ADDENDUM NO. 4
Request for Tender No. 24-01-00517

Milton Town Hall & Fire Station No. 2
HVAC Equipment Replacement

ADDENDUM No. 4

PROJECT:	H.V.A.C. Replacement at Town Hall & Fire Station #2	DATE:	23 Oct. 2024
PROJECT #:	24034	FROM:	Binayak Raj Maurya
TO:	Town of Milton	ATTENTION:	Daniele Santos

**M 0.4**

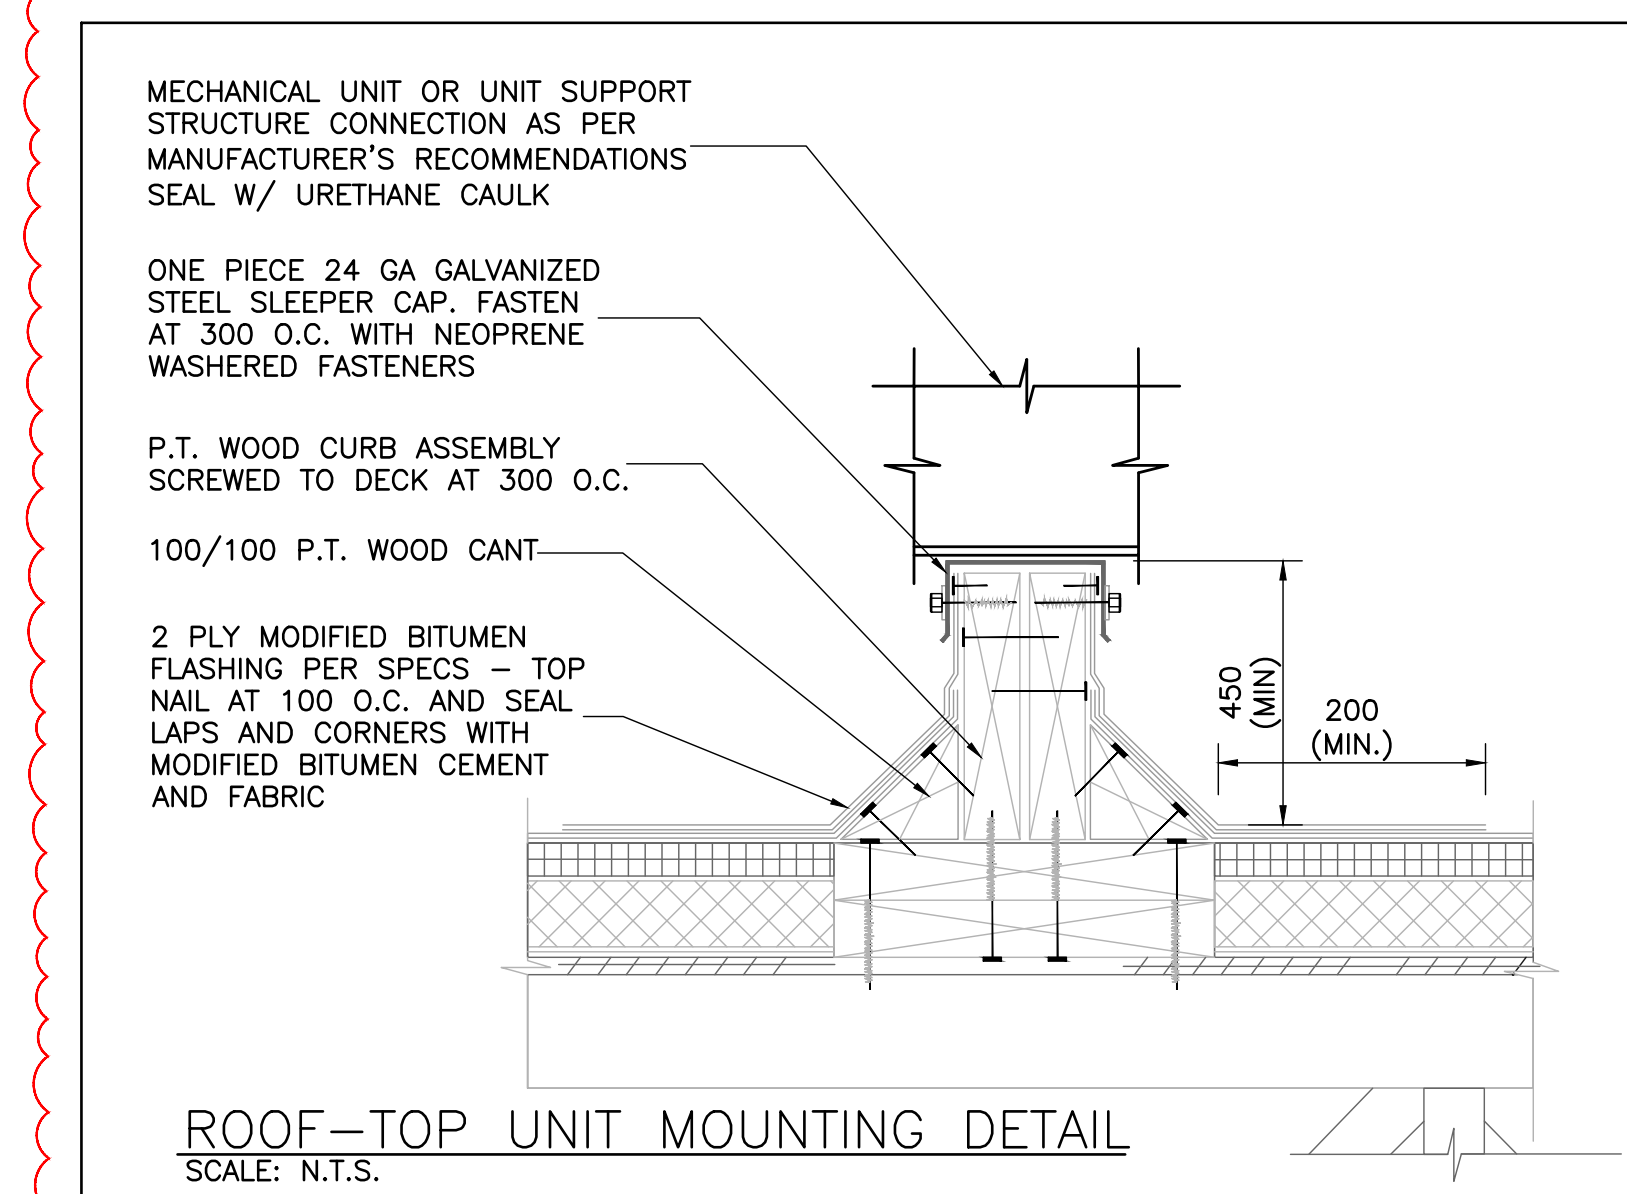
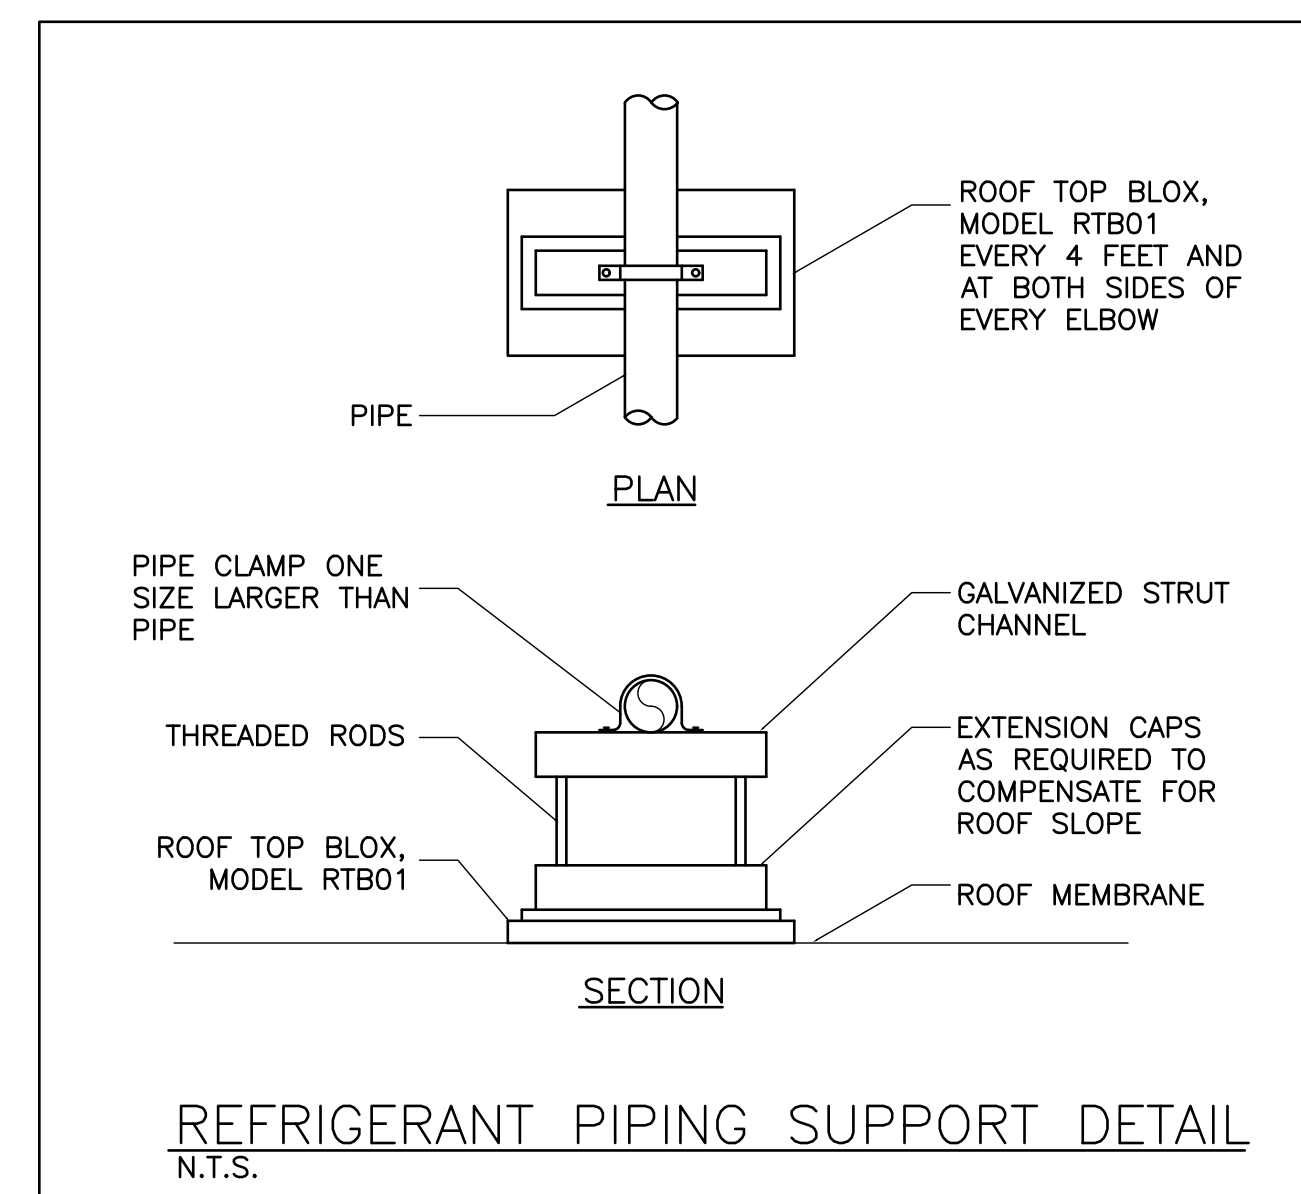
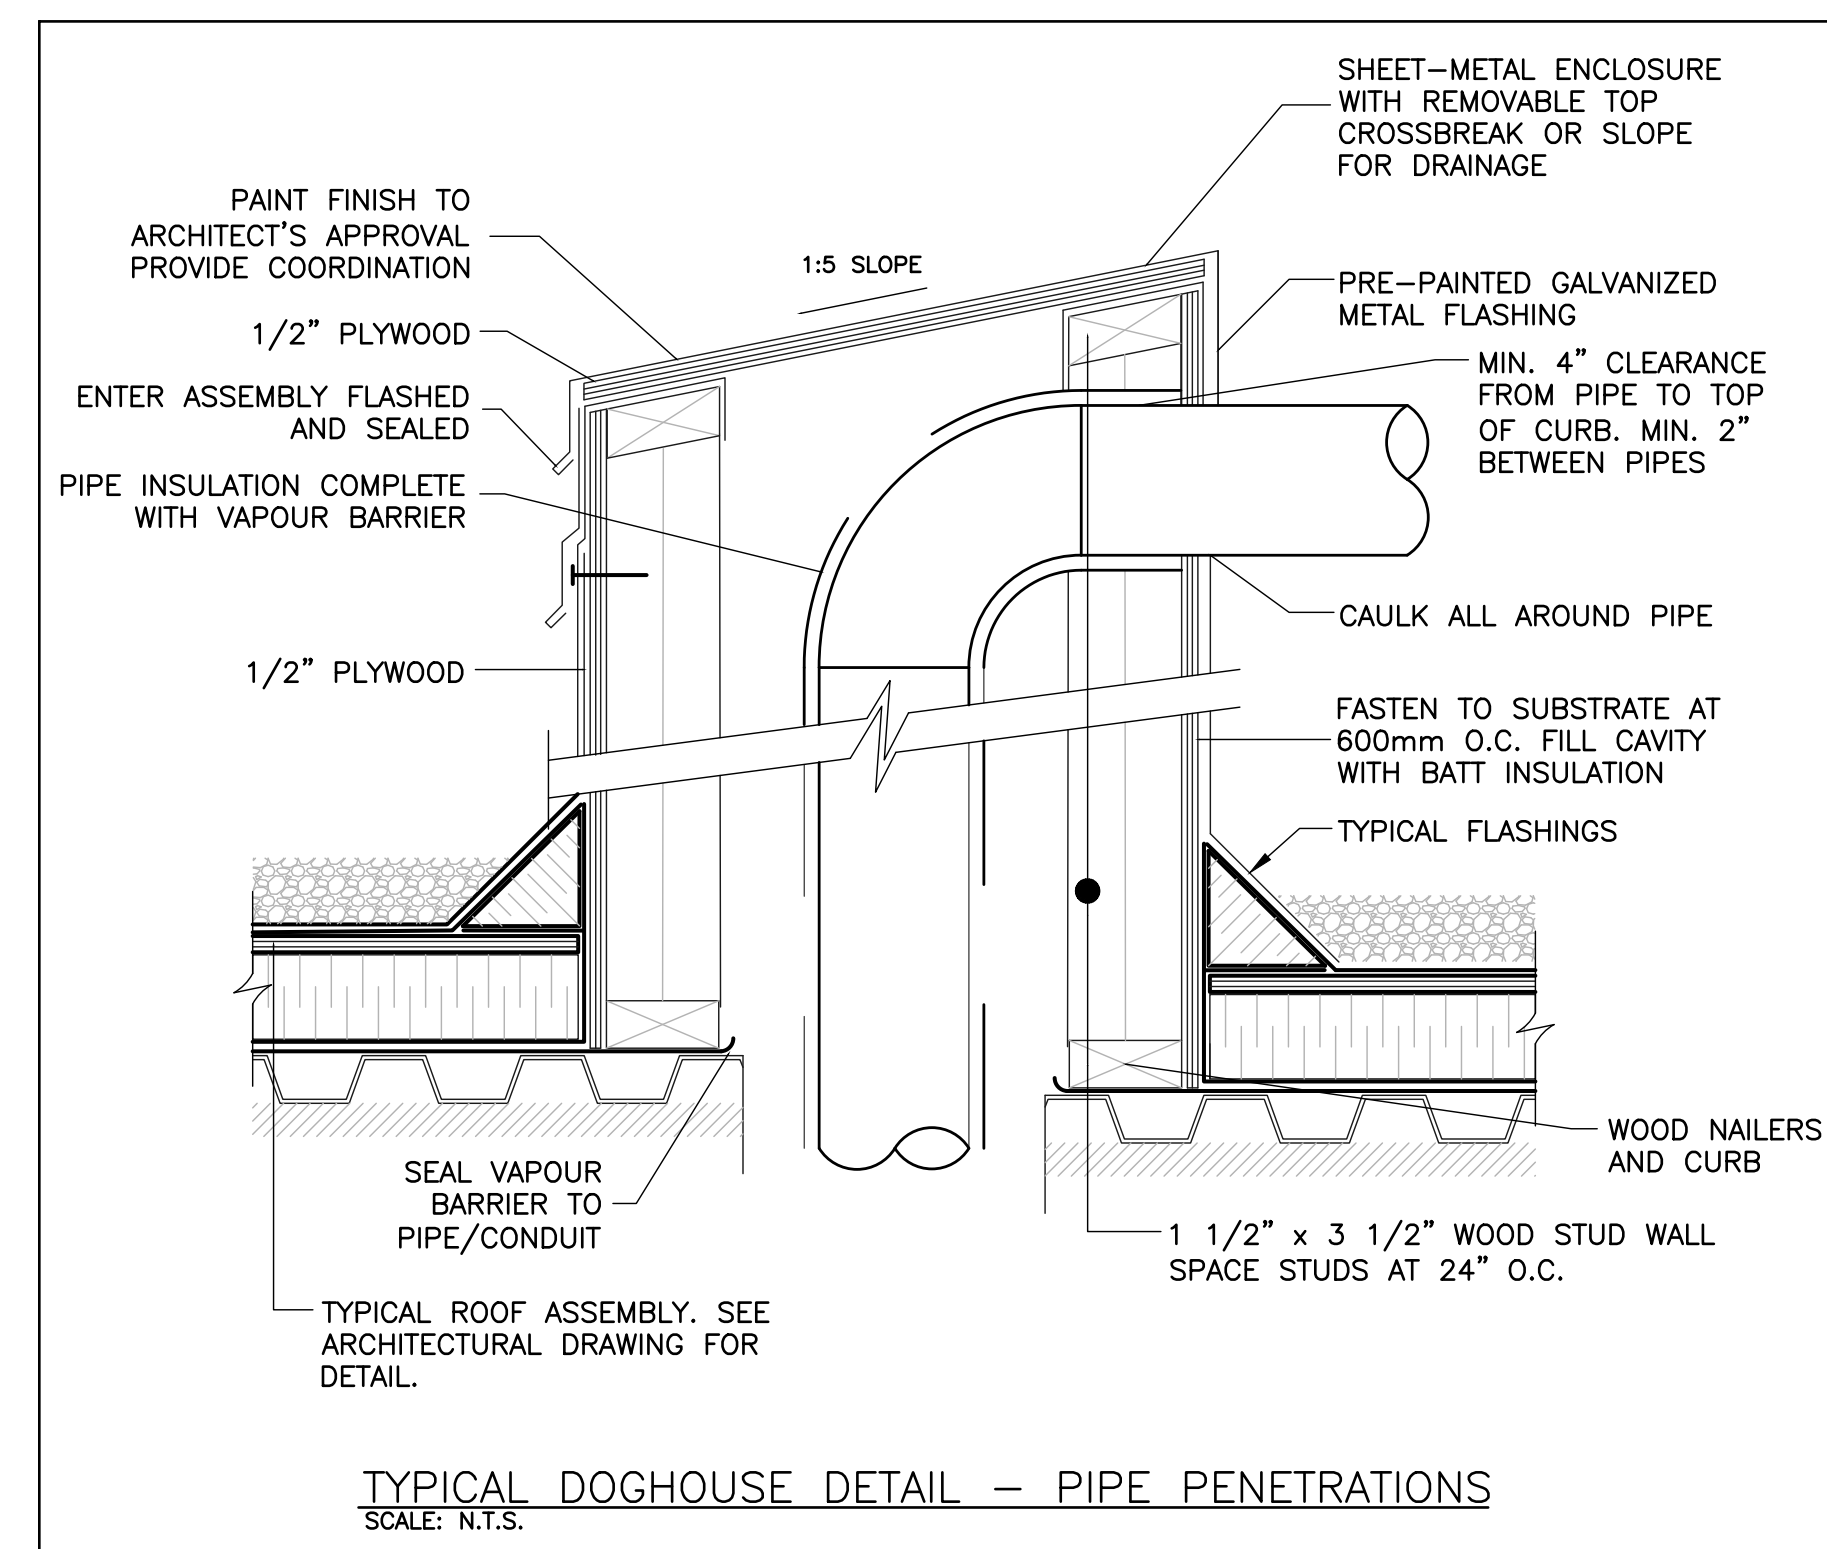
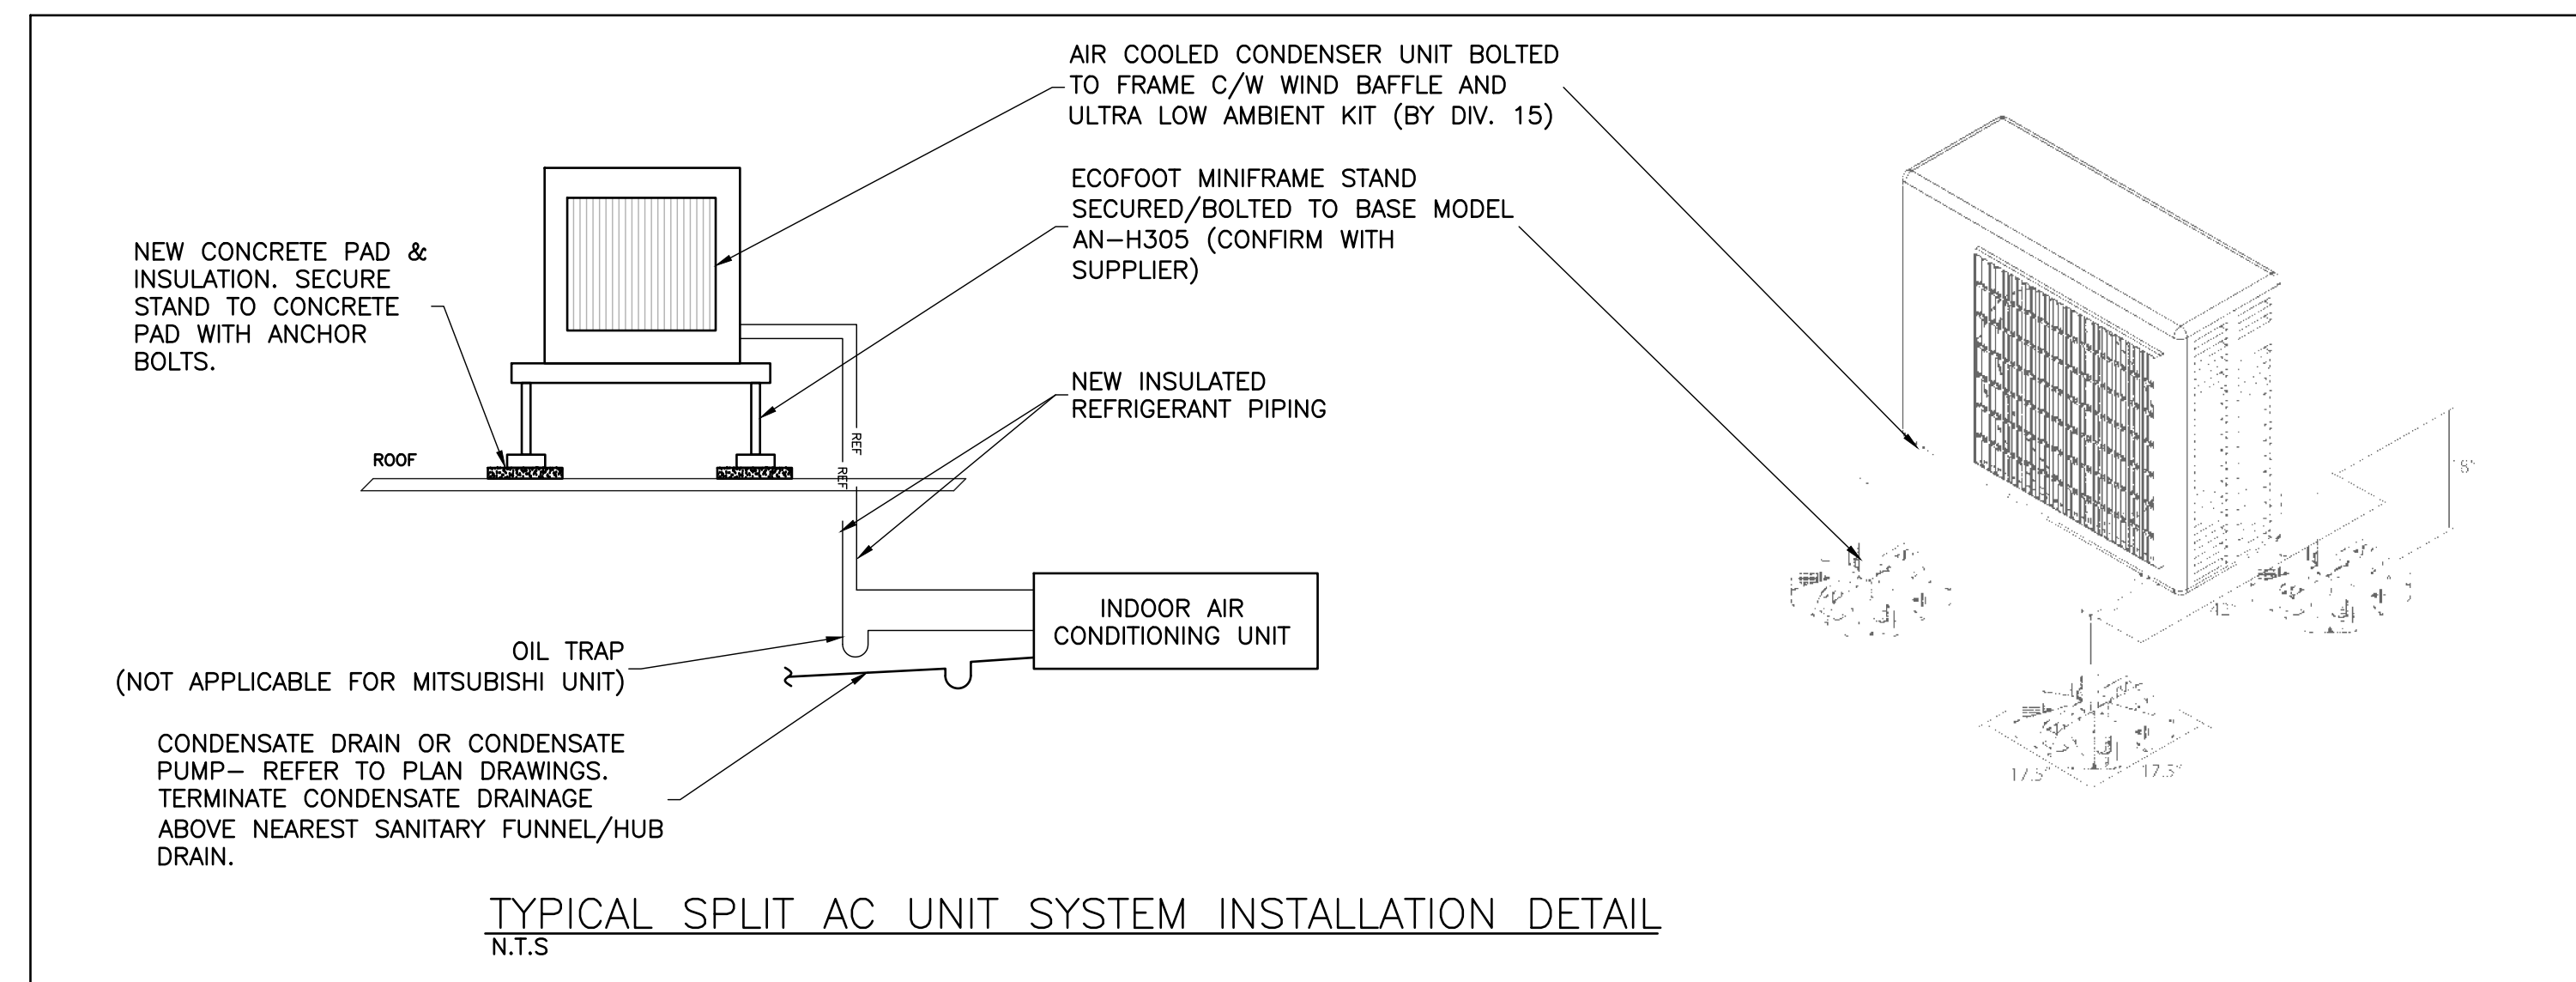
1.2 Refer to Mechanical Drawing M0.4 Rev. C

- Revised airflow rate for C/R AC-1,2.

C/R AC UNIT SCHEDULE - TOWN HALL																								
INDOOR UNIT													OUTDOOR UNIT											
INDOOR UNIT TAG	INDOOR UNIT MAKE AND MODEL No.	OUTDOOR UNIT TAG	OUTDOOR UNIT MAKE AND MODEL No.	OPERATING RANGE DB (°F)	REFRIGERANT	UNIT LOCATION	MOUNTING TYPE	MAX AIRFLOW (CFM)	ESP (IN. WC)	NET COOLING CAPACITY (kW)	SENSIBLE COOLING CAPACITY (kW)	ELECTRICAL			WEIGHT (LBS)	UNIT LOCATION	MOUNTING TYPE	COOLING CAPACITY (Btu/hr)	ELECTRICAL			WEIGHT (LBS)	SOUND (dBa)	REMARKS
												V/PH/HZ	FLA	BREAKER SIZE					V/PH/HZ	FLA	BREAKER SIZE			
C/R AC-1.2	LIEBERT DS070A	CU-1,2	LIEBERT MCM080E	50 TO 104	R407C	I.T. DATA CENTRE	FLOOR MOUNT ON 18" STANDS LEVEL WITH RAISED FLOOR	9,600	0.2	74.1	73.2	575/3/60	46.4	60	1970	ROOF	18" LEGS	N/A	575/3/60	2.4	15	906	N/A	SEE NOTES BELOW
